Contract #: 04-0120F4Cty: SF/ALA Rte: 80 PM: 13.2/13.9File #: 69.25B**QUALITY ASSURANCE -- NON-CONFORMANCE REPORT****Location:** Changxing Island, Shanghai, China**Report No:** NCR-000926**Prime Contractor:** American Bridge/Fluor Enterprises, a JV**Date:** 26-Nov-2010**Submitting Contractor:** Zhenhua Port Machinery Company, Ltd (ZPMC), Changxing Island**NCR #:** ZPMC-0888**Type of problem:**

**Reference Description:** Excessive Root Openings on Lift 14E Hinge A Bulkhead Stiffeners Discovered by QA**Description of Non-Conformance:**

**Subject:** NCR No. ZPMC-0888

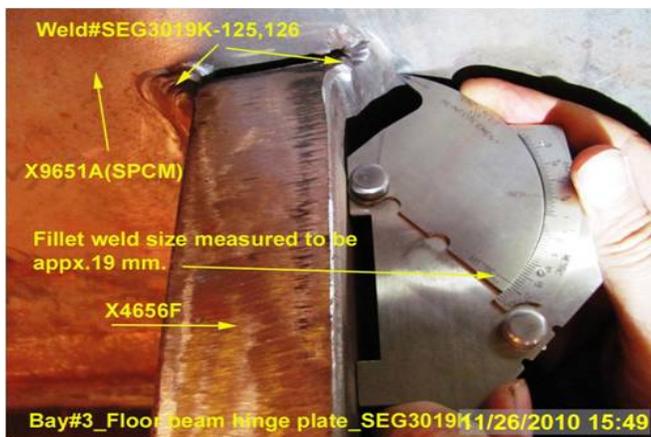
During Quality Assurance Visual Testing and Magnetic Particle Testing (MT) review of welds located on Orthotropic Box Girder (OBG) 14 East Hinge A Bulkhead on SEG3019K, this Quality Assurance Inspector (QA) discovered the following issues:

- ZPMC welded two joints with an excessive root opening.
- The root opening measured approximately 6 mm.
- The root opening exceeds the maximum tolerance specified in Caltrans approved Welding Procedure Specification WPS-B-T-2132-3 and AWS D1.5/2002 Section 3.3.1.
- The welds are identified as: SEG3019K-125,126.
- The floor beam web plate is Seismic Performance Critical Material (SPCM).
- The welds are Fillet welds joining to web plate identified as (X9651A-SPCM) to stiffener plate (X4656F).
- The fillet weld size is approximately 19 mm
- The required fillet weld size is 15 mm.
- The web plate material thickness is 25 mm and stiffener plate is 45 mm.
- The hinge plate is located in Sub assembly Bay#3.

AWS D1.5/2002 Section 3.3.1- "The parts to be joined by fillet welds shall be brought into as close contact as practicable. The root opening shall not exceed 5 mm [3/16 in.]..."

Contract Approved Welding Procedure Specification: WPS-B-T-2132-3 specifies the root opening to be 0~2 mm.

**Reference Resolution:** ZPMC has changed the fillet weld into a single CJP with new weld ID, SEG3019K-127 with the Engineer's approval. ZPMC has changed the fillet weld into a single CJP with new weld ID, SEG3019K-127 with the Engineer's approval. Attached is NDT documentation of the weld showing it is acceptable, based on this ZPMC requests closure of this NCR.

The proposed resolution is acceptable. This NCR is considered closed.

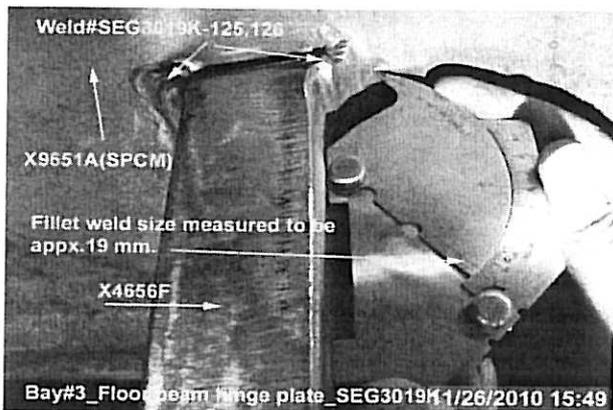
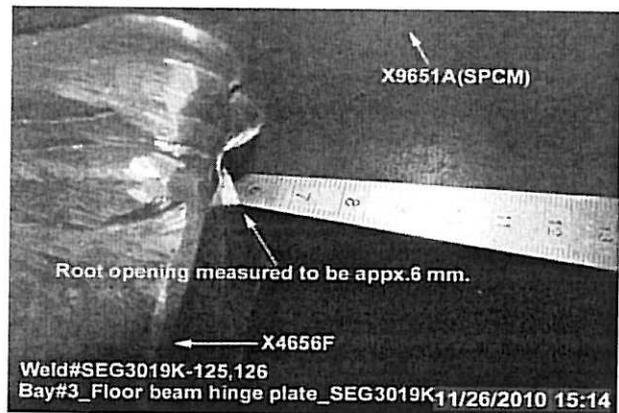
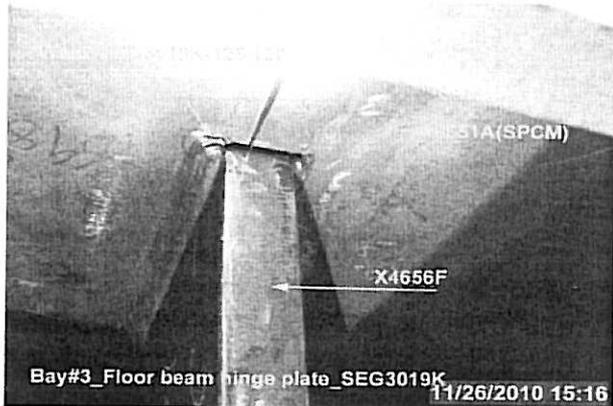
During Quality Assurance Visual Testing and Magnetic Particle Testing (MT) review of welds located on Orthotropic Box Girder (OBG) 14 East Hinge A Bulkhead on SEG3019K, this Quality Assurance Inspector (QA) discovered the following issues:

- ZPMC welded two joints with an excessive root opening.
- The root opening measured approximately 6 mm.
- The root opening exceeds the maximum tolerance specified in Caltrans approved Welding Procedure Specification WPS-B-T-2132-3 and AWS D1.5/2002 Section 3.3.1.
- The welds are identified as: SEG3019K-125,126.
- The floor beam web plate is Seismic Performance Critical Material (SPCM).
- The welds are Fillet welds joining to web plate identified as (X9651A-SPCM) to stiffener plate (X4656F).
- The fillet weld size is approximately 19 mm
- The required fillet weld size is 15 mm.
- The web plate material thickness is 25 mm and stiffener plate is 45 mm.
- The hinge plate is located in Sub assembly Bay#3.

AWS D1.5/2002 Section 3.3.1- "The parts to be joined by fillet welds shall be brought into as close contact as practicable. The root opening shall not exceed 5 mm [3/16 in.]..."

Contract Approved Welding Procedure Specification: WPS-B-T-2132-3 specifies the root opening to be 0~2 mm.

Contractor proposes to change the fillet weld into a single CJP with new weld ID, SEG3019K-127 with the Engineer's approval. Contractor will provide the NDT report to show the weld is acceptable.
